MALHEUR EXPERIMENT STATION IRRIGATION SYSTEM RENEWAL

INVITATION TO BID (ITB) # 2026-019692

ADDENDUM NO. 2

ISSUE DATE: September 16, 2025

LINE A
PLAN & PROFILE

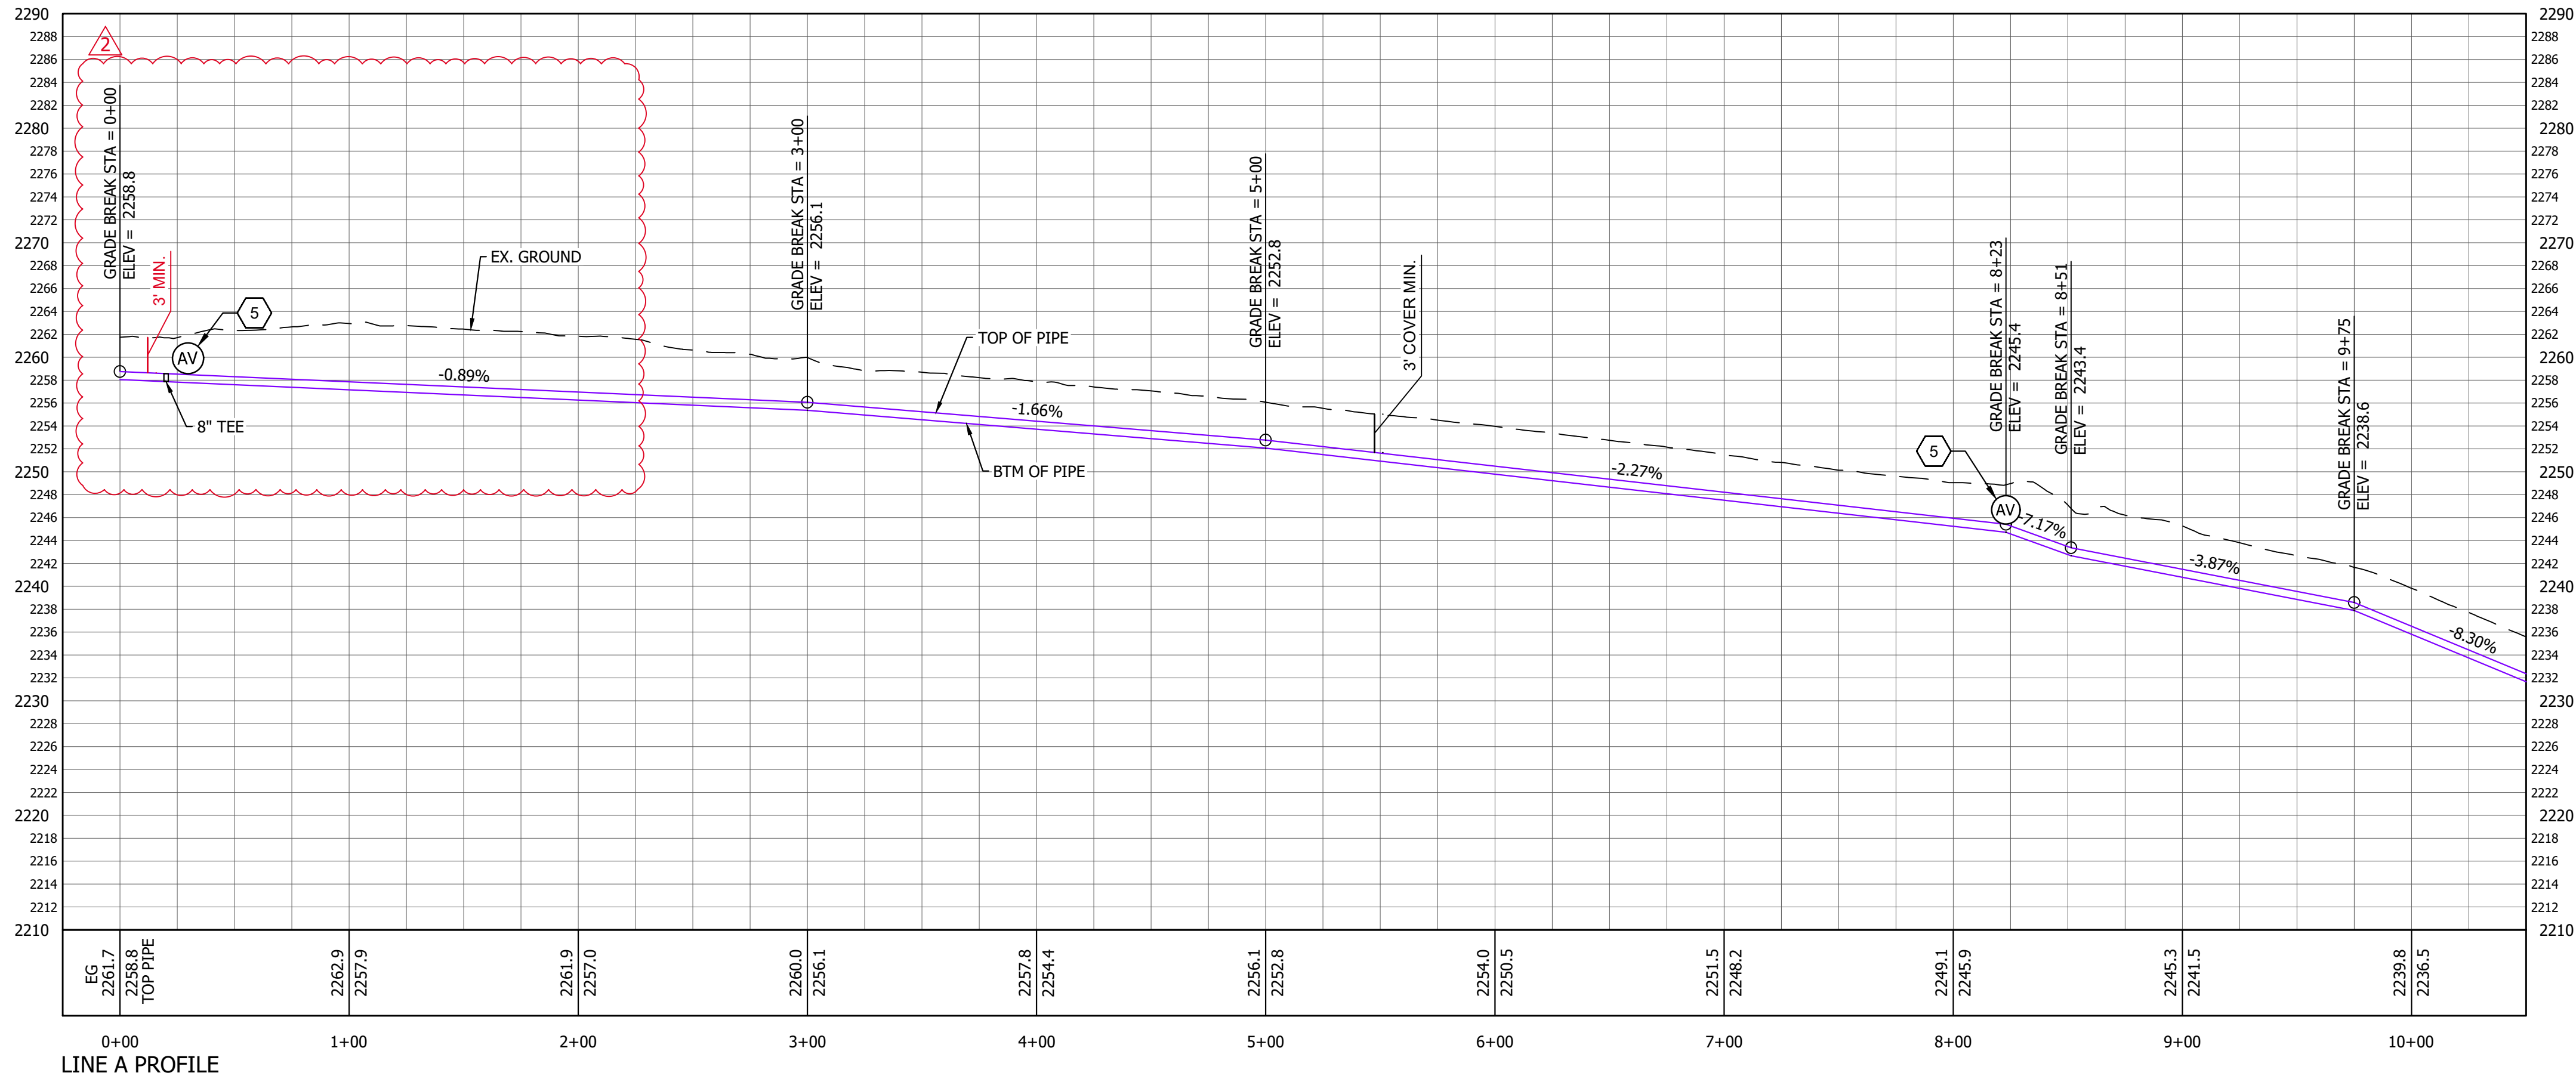
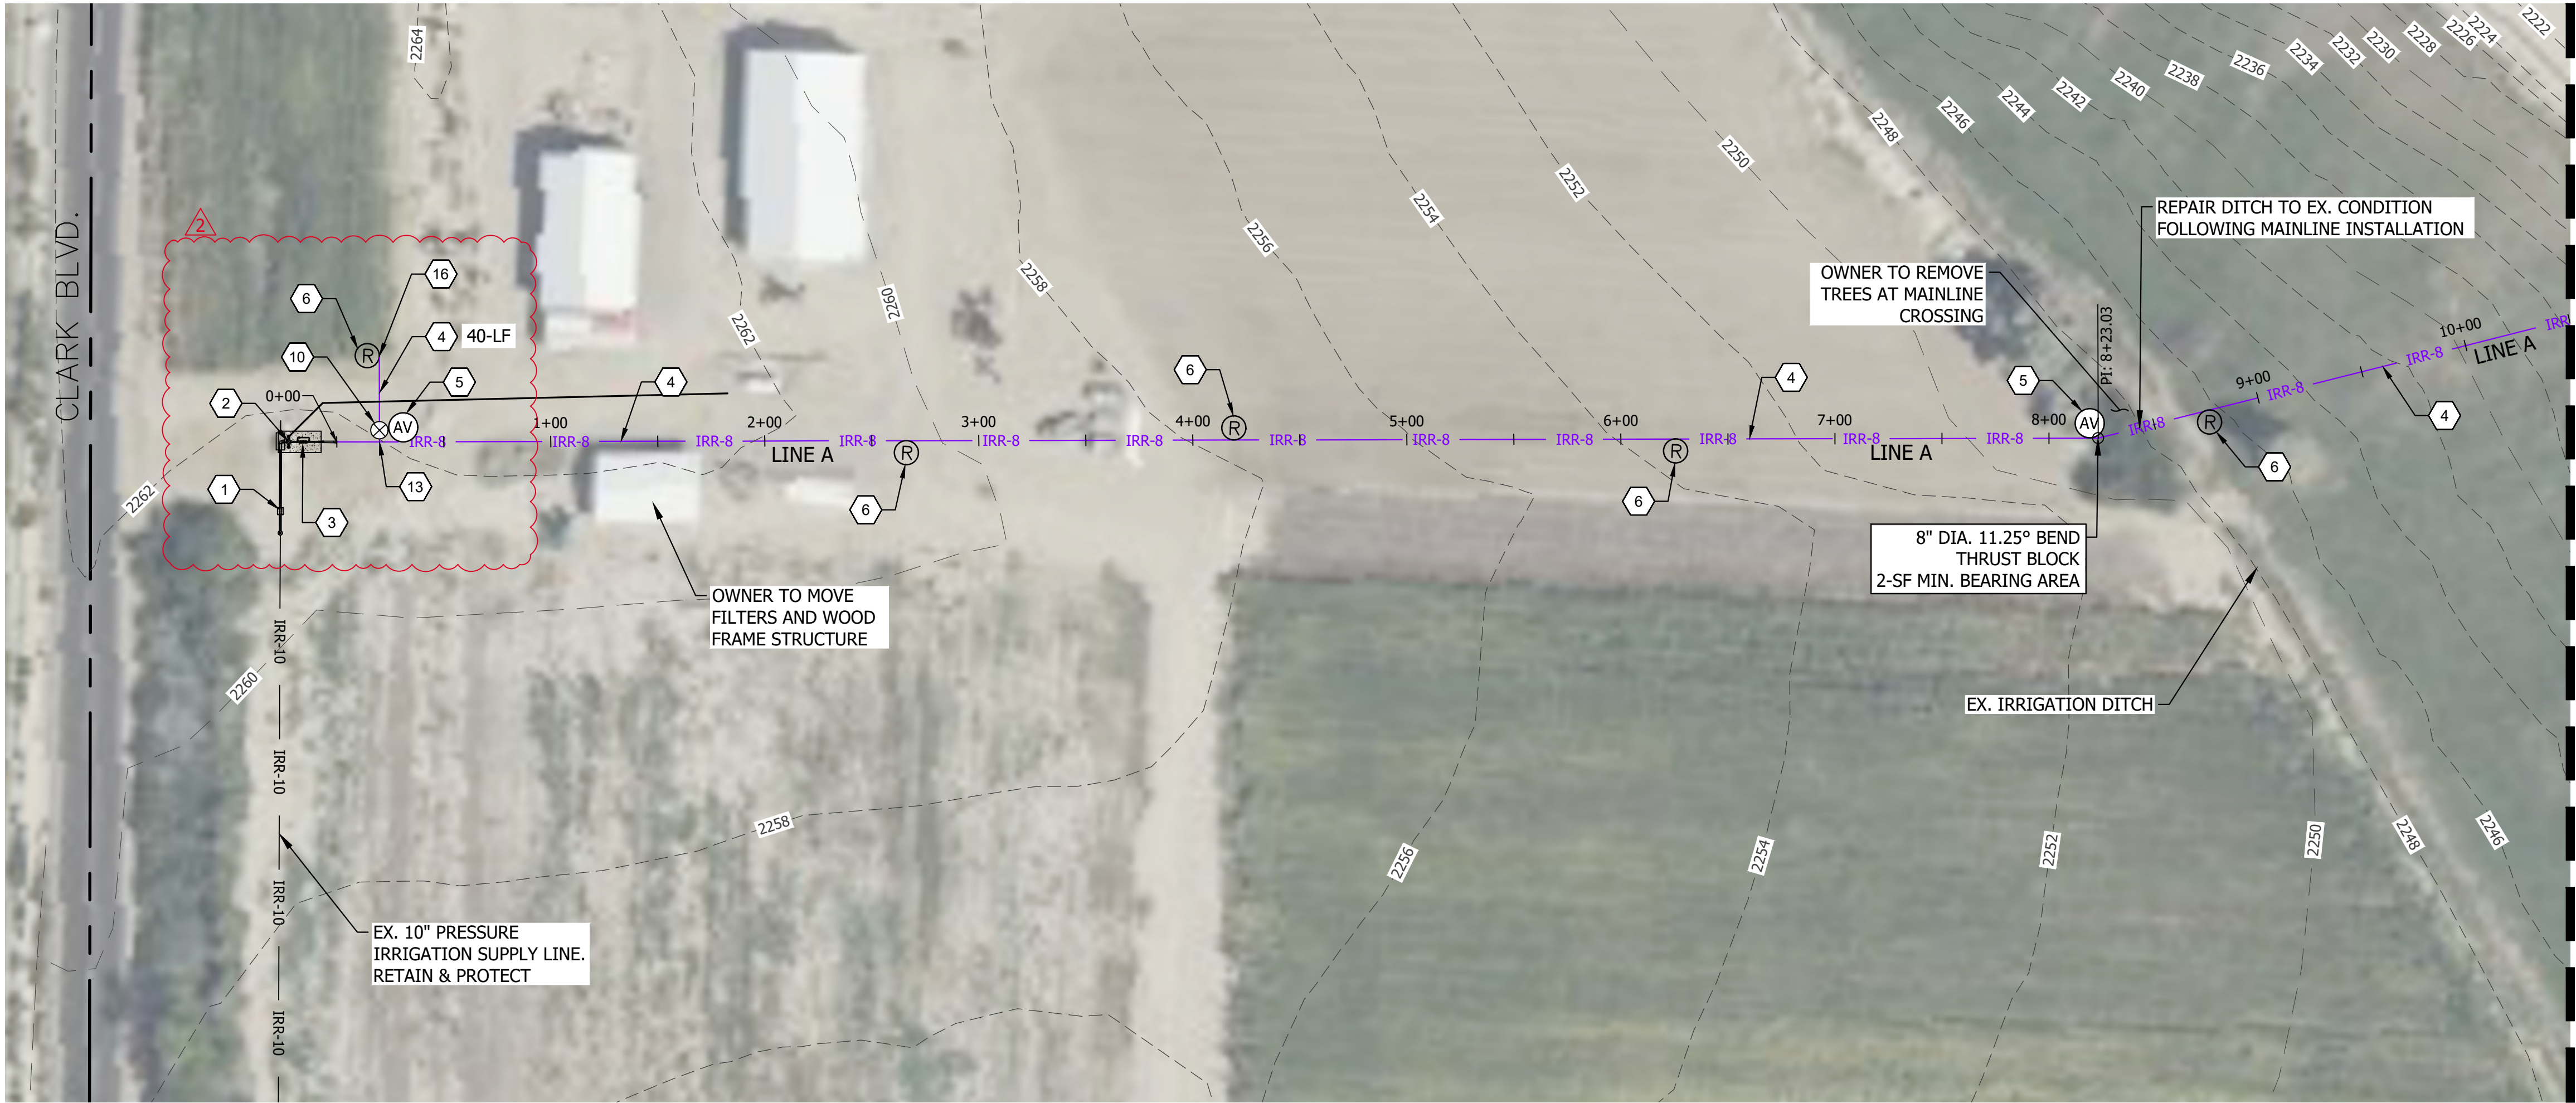
- Item 8 Eliminate PRVs and CAV's at each riser, we have them on the ends of the pipeline and will be sufficient.
Modification request not accepted.
- Item 9 Run filter flush water into existing irrigation pipeline that drains to the east, it can be used for flood or it can dump into lower pond.
Modification request accepted. See Sheets C200 and C501 attached to this addendum.

1. RAISE EXISTING 10" DIA. FLOWMETER MANIFOLD PER DETAIL 1, SHEET C500.
2. INSTALL PRESSURE FILTERS PER DETAIL 4, SHEET C501.
3. INSTALL PRV STATION PER DETAIL 4, SHEET C501.
